TRAILER SUSPENSION

TECHNICAL BULLETIN

No: 97117-177
Subject: HT 230 Lower Shock Absorber Bracket
Date: February – 2009 Revision C

Figure 1.

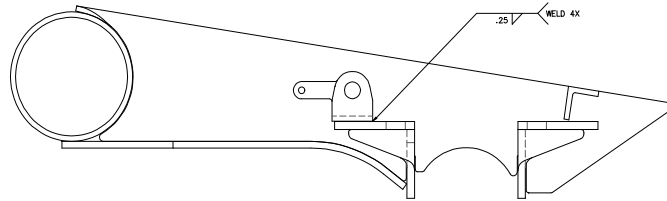
Instances of a cracked weld around the trailing arm shock absorber bracket have been reported. In the event that the lower shock absorber clevis becomes detached, or a crack is detected at the connection to the trailing arm (see Figure 1), the clevis can be effectively replaced.

Kit Part number 98544-021 is available to effect the repair. The kit contains a replacement clevis, shock absorber bolt and reinforcement gusset block. Where the weld retaining the original clevis has cracked, or the clevis has become detached, grind off the remaining weld. It is paramount that cracks or damage to the trailer arm plate are ground, welded and the area is smooth and flat prior to the new clevis being fitted.

- a. Position the reinforcement gusset Part No. 98870-004 with the chamfered edge toward the trailing arm.
- b. Apply a weld around the block in one continuous bead commencing and terminating ten millimetres from the existing beam weld.
- c. Bolt the clevis to the gusset block with the bolt provided. Weld the clevis to the gusset block in one continuous bead.
- d. Clean and paint the repaired area.
